Reevaluating Kosovo's Least Cost Electricity Option

Preliminary Evaluation of the World Bank's December, 2011 "Background Paper,
Development and Evaluation of Power Supply Options for Kosovo"

Bruce C. Buckheit
January 2012

The Sierra Club
The Kosovar Institute for Development Policy
(INDEP)

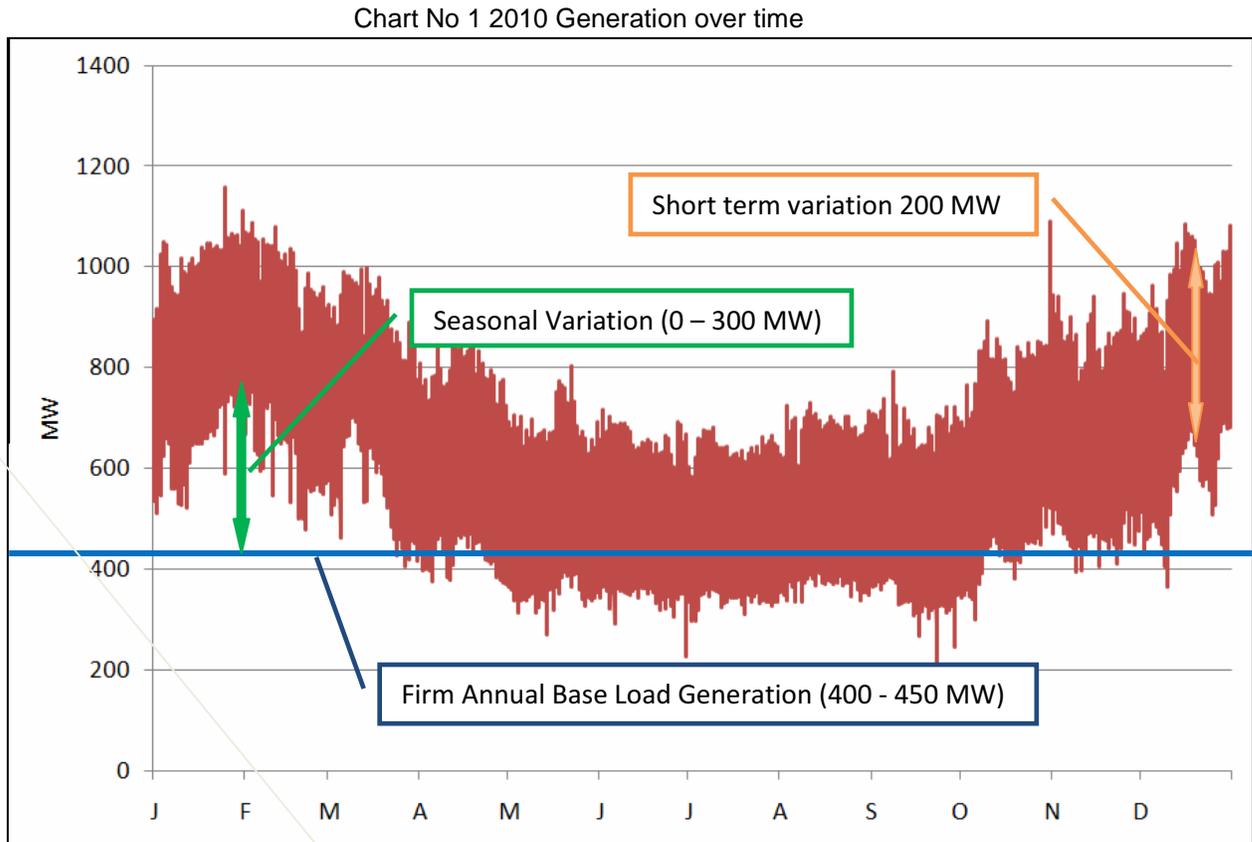
The WB Background Paper includes plots of electric consumption (including technical and nontechnical losses) for 2010. These plots are reproduced and annotated below.

Net consumption by consumers (residential and commercial) is reported in the WB Background Paper at 57 per cent of the amounts generated. Thus, the actual base load consumption (assuming no losses) in 2010 was met by 228 MW of generation. If the “distribution” losses are reduced from 17 percent to 5 percent and “commercial” losses similarly reduced from 24 percent to 5 percent (and assuming a price elasticity of -0.4) then net base load consumption rises by an equivalent of 11.4 MW (since those who had been getting “free” (i.e. stolen) or unmetered electricity would now pay for and consume 60 percent of the earlier amounts). However, net base load consumption rises to 80 per cent of firm base load net generation – and can be met by 320-340 MW of firm annual base load generation. Thus, if distribution and “commercial” losses are reduced to levels commonly experienced throughout the world, a refurbished Kosovo B (618 MW

A review of the current daily generation and demand forecast by KEK reveals that current needs for peaking generation are as suggested by the above data. Daily variations in demand are approximately 200MW. The hourly rate of change in demand in the morning and evening exceeds 50MW/hr which is largely met by purchased power (imports). The WB Background document reports that import prices for peaking power are up to €113/MWh and that imports are not available at some times of peak demand, leading to load shedding. This is consistent with pricing patterns in the United States. While the full distribution of hourly import prices has not been evaluated, it appears likely that the Zhur power plant (at the WB estimate of €96/MWh) is more cost effective than purchasing power to serve peak needs. However, the estimated annual capacity of Zhur is only about half of the peaking power needs of Kosovo and so some continued purchases or additional peaking generation capacity will likely be needed.

Chart No. 2 Cumulative Generation

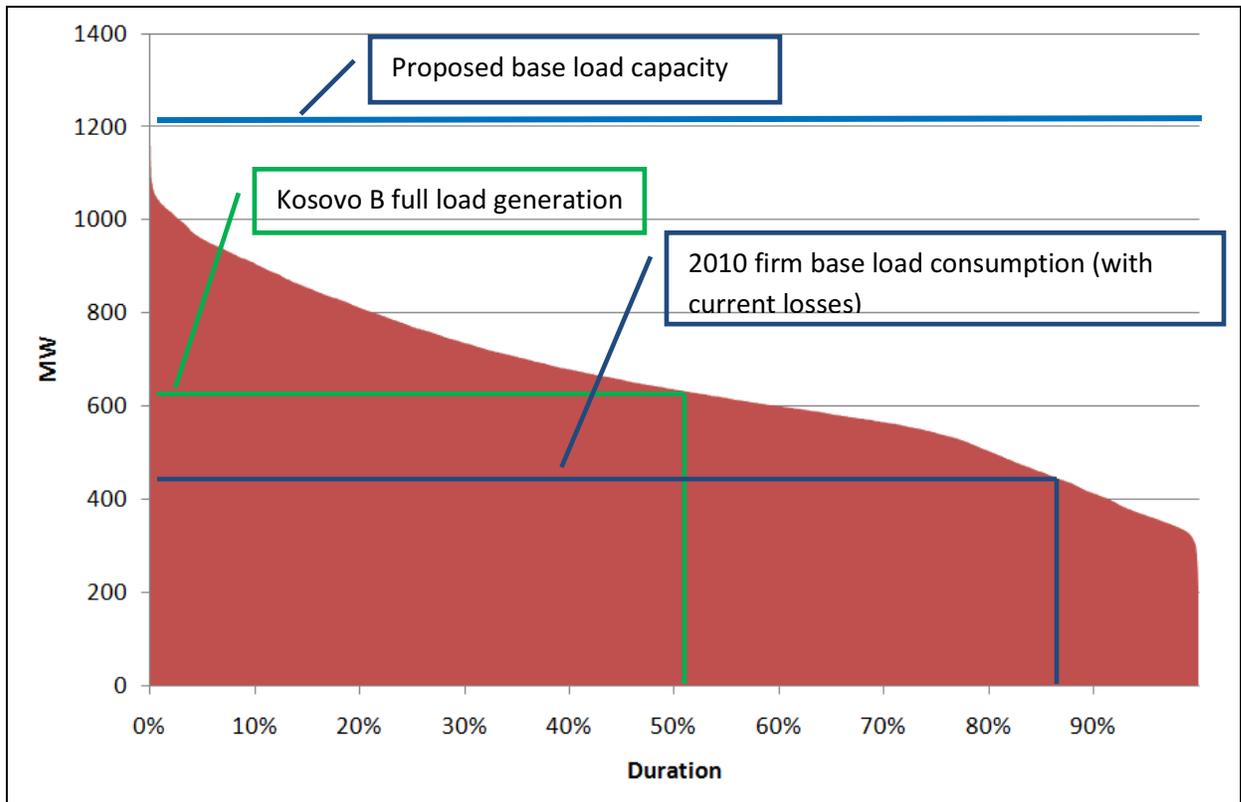
The data from Chart No. 2 shows that, with 2010 levels of technical losses and theft, the firm base load level⁶ was slightly above 400 MW and that the generation needed to meet demand (and cover losses) would have required full load operation of a refurbished Kosovo B plant only 50 percent of the time. If technical and non-technical losses are each reduced to five percent, the values of the vertical axis of the chart are reduced by 20 percent.⁷ The full base load need of the system is reduced to 340 MW and a refurbished Kosovo B plant would only need to operate at full load 20 percent of the time to meet this demand. If the full base load demand is assumed to grow by the high end suggested by the World Bank Background Paper (4.5 percent per annum), the

⁷ Since it is reasonable to assume that the reduction in losses is uniform across the load profile the shape of the curve should not vary significantly, but simply be reduced such that, where the vertical axis in Chart 2 reads 400 MW, it would become 320 MW and where the vertical axis of the Chart reads 800 MW, it would become 640 MW. The proposed base load capacity would remain at 1200 MW.
